**NOTICE OF A TYPE II DECISION ON A PROPOSAL IN YOUR NEIGHBORHOOD**

**CASE FILE NUMBER: LU 08-122163 DZ – 910 NW 10<sup>TH</sup> AVENUE,  
BANNER BANK ATM**

The applicant requests design review for the installation of an ATM machine within the existing concrete entry frame at the southwest corner of the Burlington Tower building located at NW 10<sup>th</sup> and NW Kearney. The ATM would serve the newly installed branch of Banner Bank which was recently approved under design review case LU 07-185754 DZ. The previous design review approval was for storefront renovations and the installation of a fireplace vent. The ATM was originally part of the earlier design review case but was removed so the tenant improvements could proceed. Design review is required for exterior alterations to buildings in design overlay zones.

DR3      064500      04.14.08

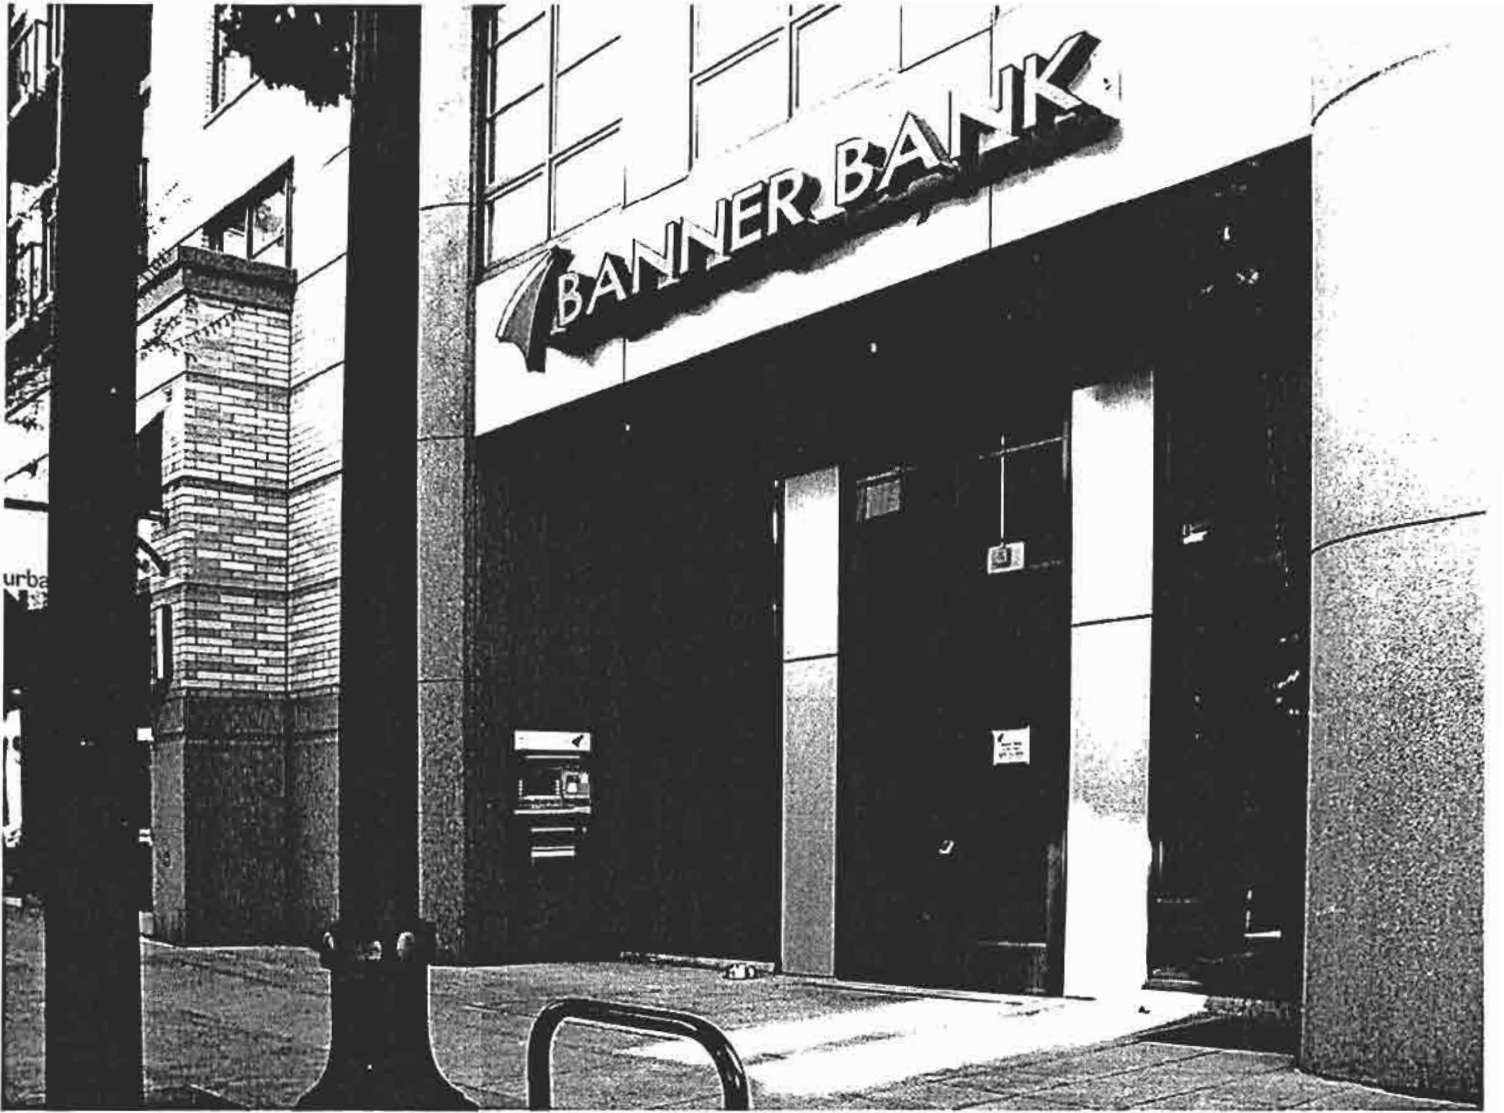
**Findings for A5 and A5-1-1:** The proposed ATM location at the base of the multi-story concrete pilaster violates the unified, monolithic tripartite composition of the building at this significant southwestern corner entry by breaking the continuous line of pre-cast concrete that surrounds the base of the building. *This guideline is therefore NOT met.*

**Findings:** Locating the ATM in the base of the existing multi-story concrete frame would require the removal of a portion of the pre-cast panel. While this is structurally possible, cutting a hole in the entry frame creates a sense of impermanence and weakness in the building structure. The ATM itself is not a permanent or high-quality architectural feature and would detract from the entry frame. Removal of the ATM is a possibility and would leave a large hole in the pre-cast concrete base panel which would be difficult to repair since any new concrete would be poured at a different time, with different batch materials, and would not have aged-in-place like the original panel. Replacement of the entire panel would suffer from the same problems of trying to match new material to old material that has been in place for a number of years. *This guideline is therefore NOT met.*

**Findings:** The southwest entry corner is an important feature of the building and was designed to feel structurally significant with its multi-story concrete frame and storefront system, detailed edges that lead the eye toward the doors, the large overhead brackets, and deep soffits. Placing the ATM within the multi-story concrete entry frame violates the original character of the existing building by making the base seem permeable instead of solid and also by interrupting the visual connection between the upper and lower portions of the frame. *This guideline is therefore NOT met.*

**Findings:** The framed corner entry feature is a critical part of the overall building composition. It gives the building a sense of permanence, marks the entrances to retail spaces and is visible from several blocks away. Placing an ATM within the base of the framed corner entry violates the coherency of the original design and detracts from the perceived permanence and importance of the corner entry composition. *This guideline is therefore NOT met.*

The installation of an ATM machine within the pre-cast base of the dramatic two-story entry frame breaks the coherent architectural composition of the existing building. The proposed location is not typical of other nearby ATMs serving other local area banks. ATM machines are not high-quality or permanent architectural features and the proposed location for this particular ATM violates the permanence inherent in this significant and highly visible southwest corner entry. Repair or replacement of the compromised pre-cast panel with matching material would be extremely difficult if the ATM were ever removed, potentially permanently damaging the building's exterior. The existing storefront configuration at this corner of the building offers a minimum of 4 potential places to install an ATM without having to penetrate the pre-cast concrete entry frame.

DR4

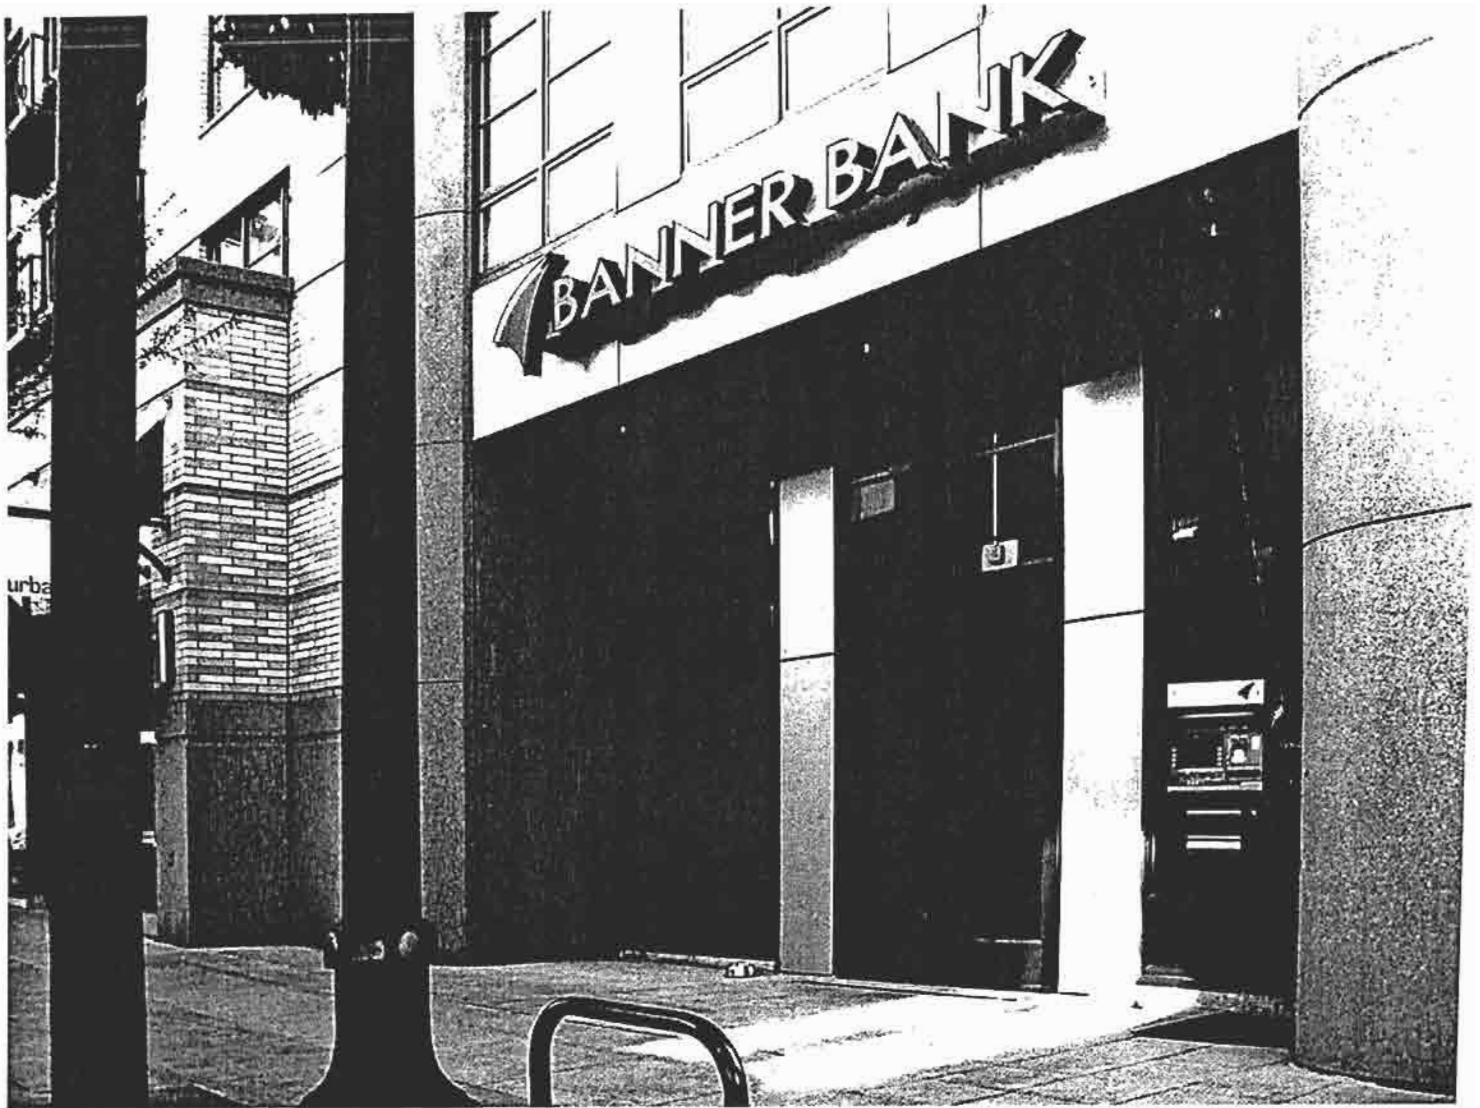
**Findings:** There are a number of other banks within a one block walk of the project site. These banks all have exterior ATMs, all of which are placed within existing storefront systems. None of the nearby ATMs are placed within significant entry features. The proposed ATM location for Banner Bank within the most significant architectural feature of the building does not follow the local design vocabulary. The existing storefront system offers a minimum of four locations at or near the corner of the building in which to place an ATM machine that would avoid penetrating the pre-cast entry frame. *This guideline is therefore NOT met.*
